ADDENDUM NO. 2

**TO THE
CONTRACT DOCUMENTS FOR
FOREMAN BUNDY REVERSE OSMOSIS WTP
WESLEY 2R WELL REHABILITATION &
CHERRY GLADE WELL CONSTRUCTION
DWI PROJECT NO.: SRP-D-134-0115
PASQUOTANK COUNTY, NORTH CAROLINA**

From: **Green Engineering, P.L.L.C.
Consulting Engineers
Wilson, North Carolina**

DRAWING SHEET 3 OF 3 – RAW WATER WELL SECTIONS:

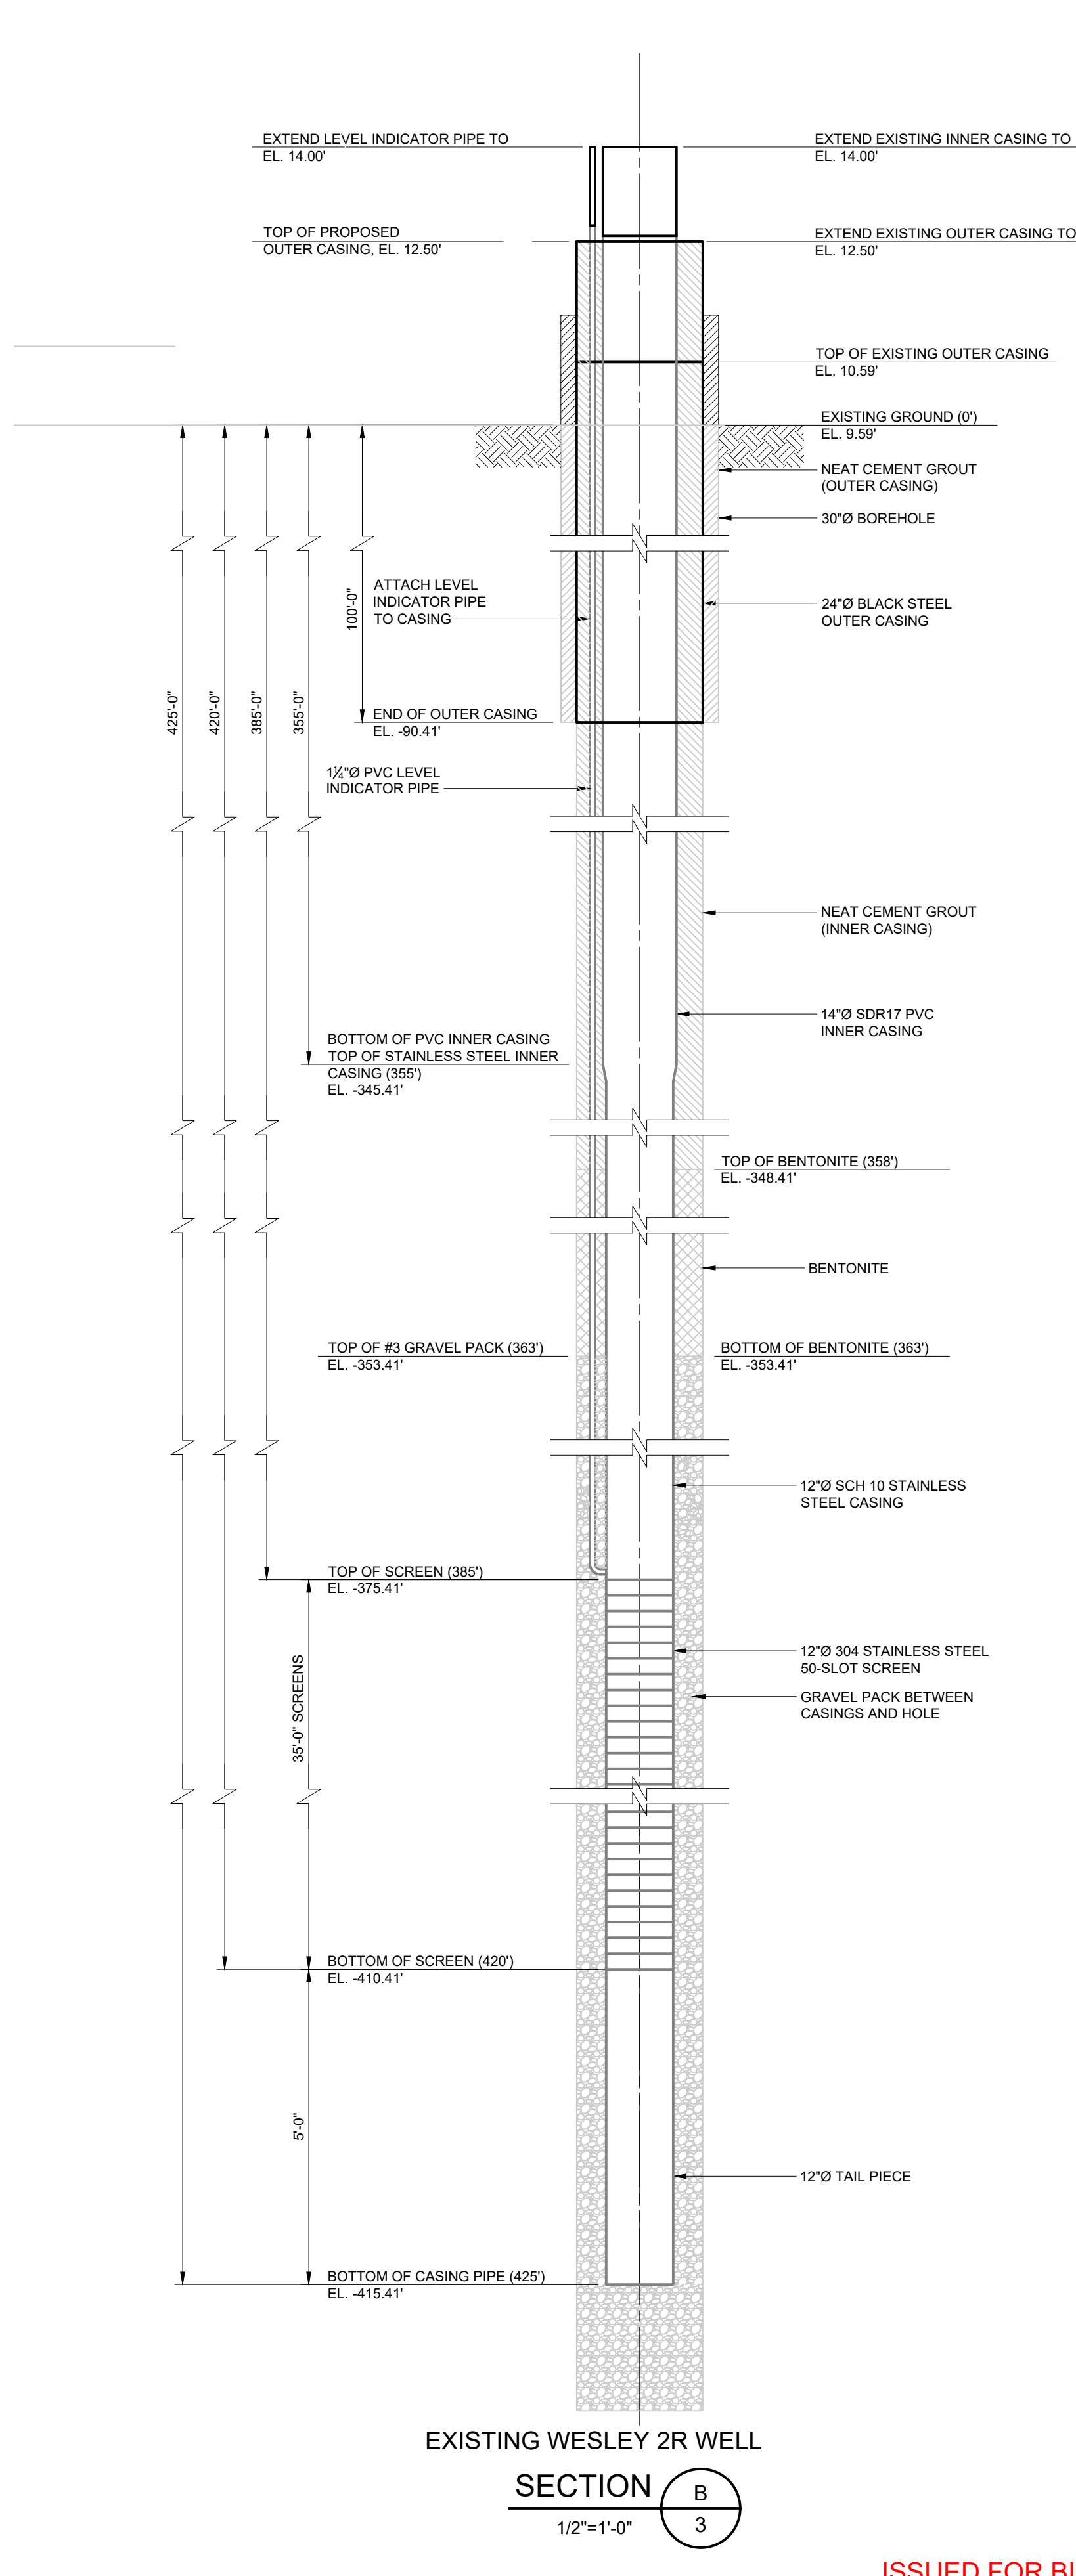
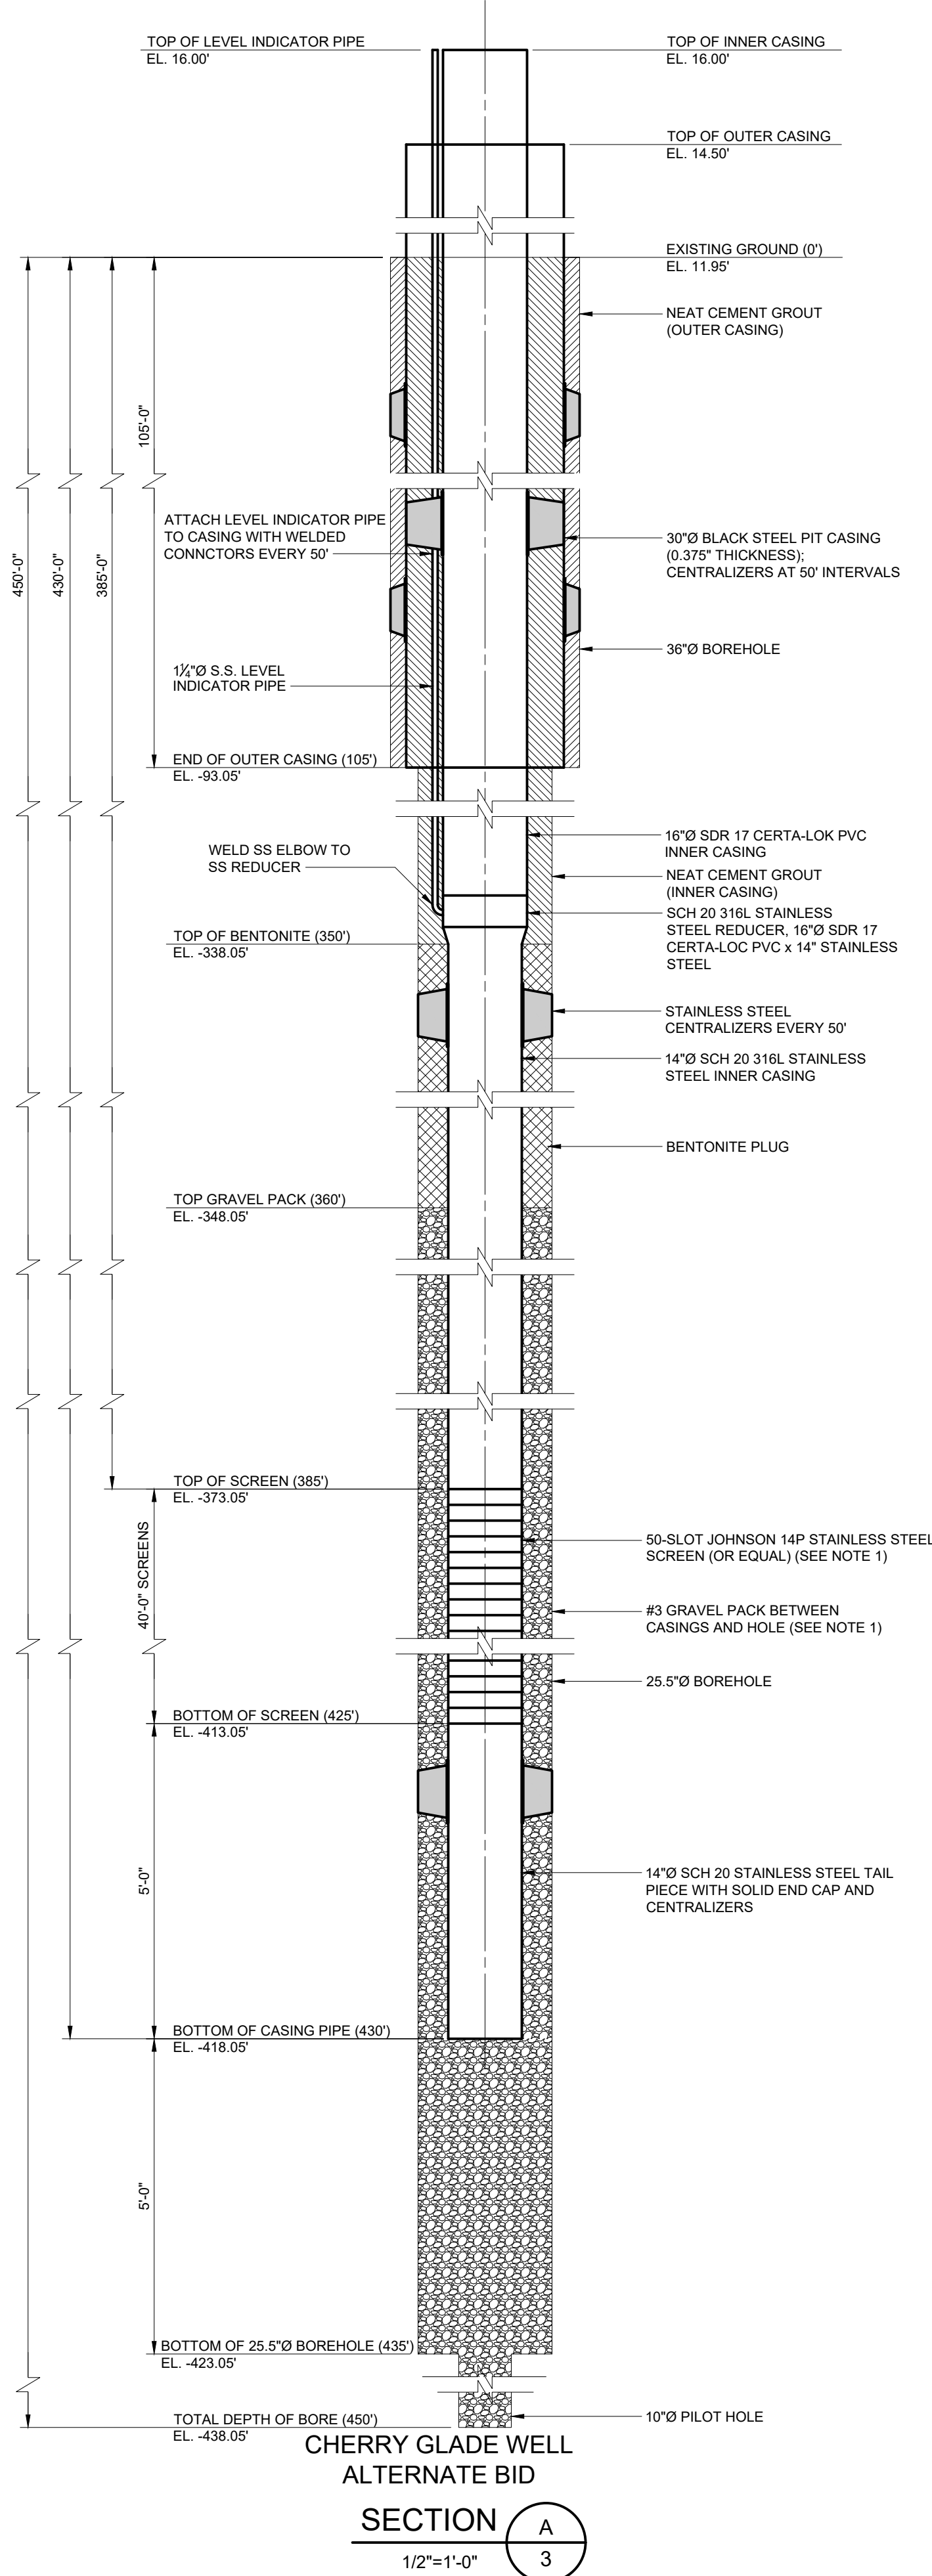
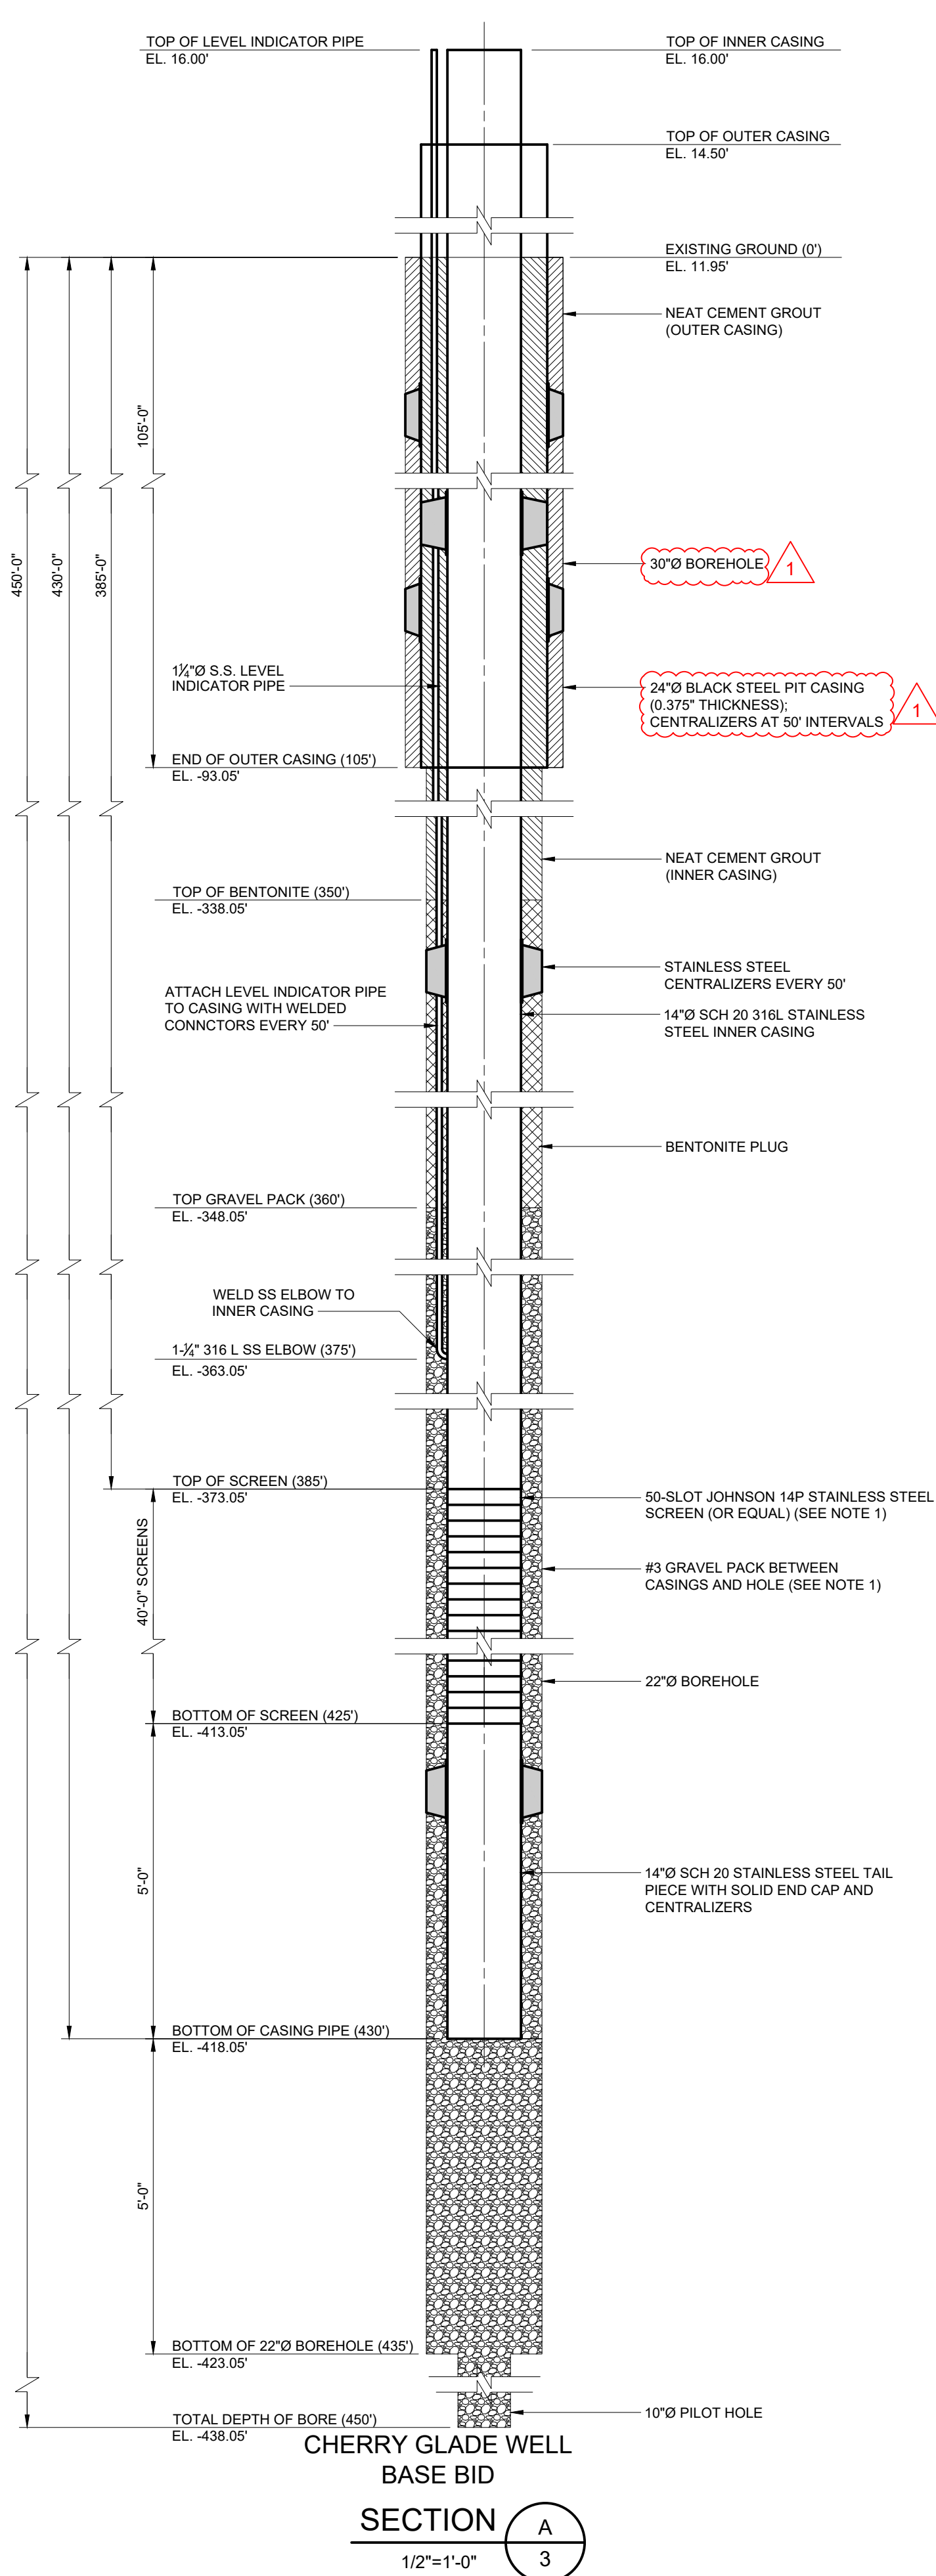
– SECTION A/3 – CHERRY GLADE WELL BASE BID – Revised diameter of pit casing to 24-inch.
